NRL/MR/7441--93-7080

# Digital Mapping, Charting, and Geodesy Analysis Program Technical Review of Urban Vector Smart Map (UV<sub>Map</sub>) Prototype 1

March 11, 1994

Figure 1. Possible digitizing error / Water courses showing "broken" lines.

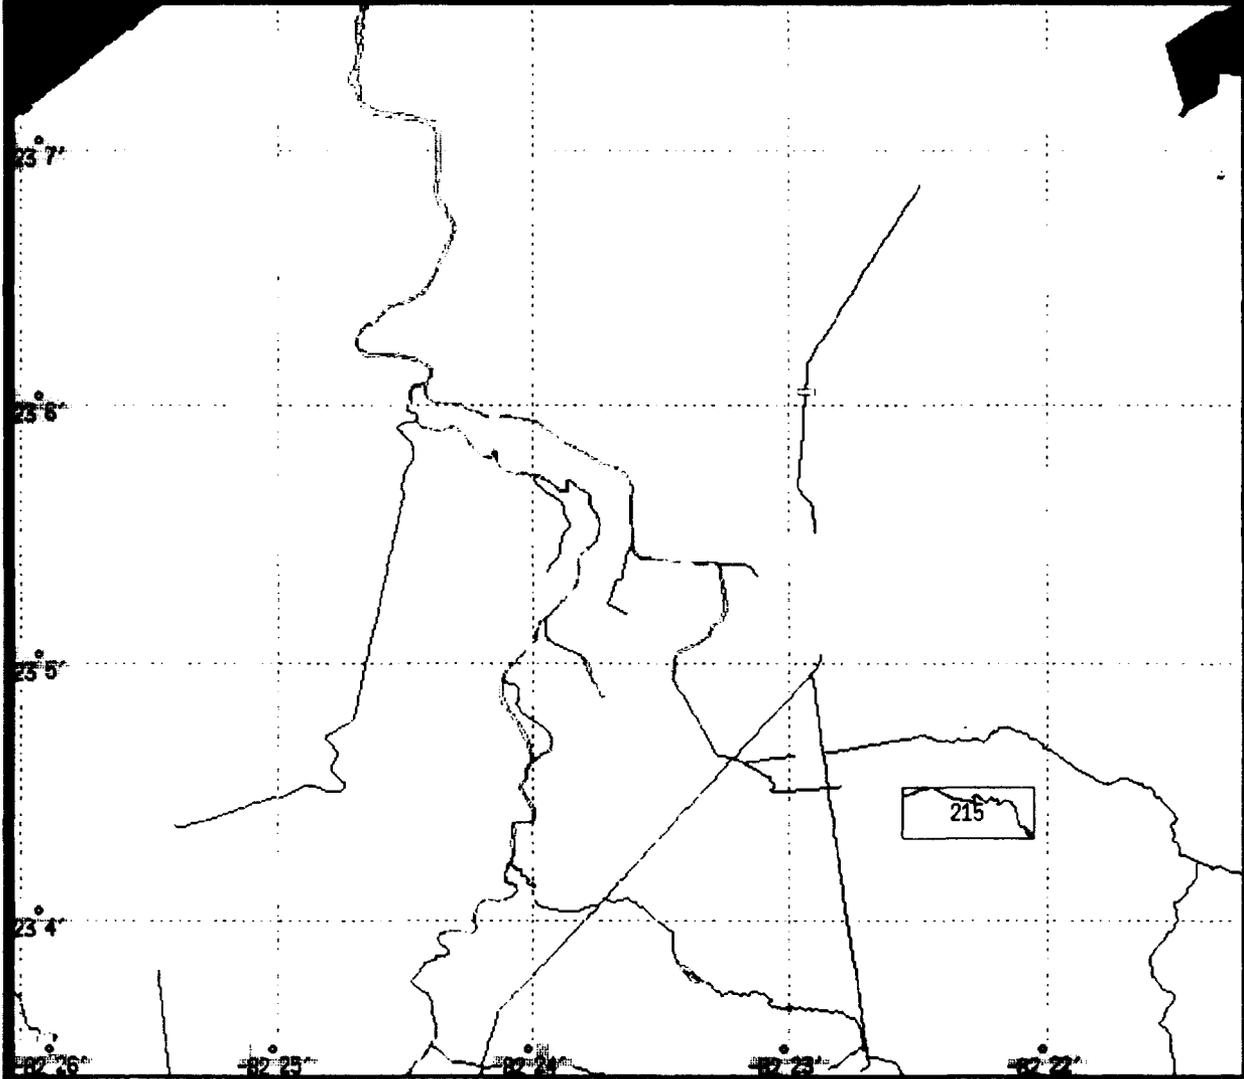
- Only one discrepancy has been detected in comparing the Havana city graphics with the digital version. Figure 1 displays a river/stream (EDGE 215) in the database that does not appear in the source charts. This could be a digitizing error or an update to the actual city graphic. If EDGE 215 is an update from the chart, this fact should be indicated.

1. A fundamental problem, relating to UV<sub>Map</sub>'s potential usefulness in GIS applications, is its inability to recognize complete objects when more than one feature comprises that object. Figure 1 demonstrates this phenomenon. Several water course lines appear to be broken, to the point that the average user could wrongly conclude that dry land was present between the water courses. In this particular view, however, some of the breaks are filled-in when aqueducts are displayed.
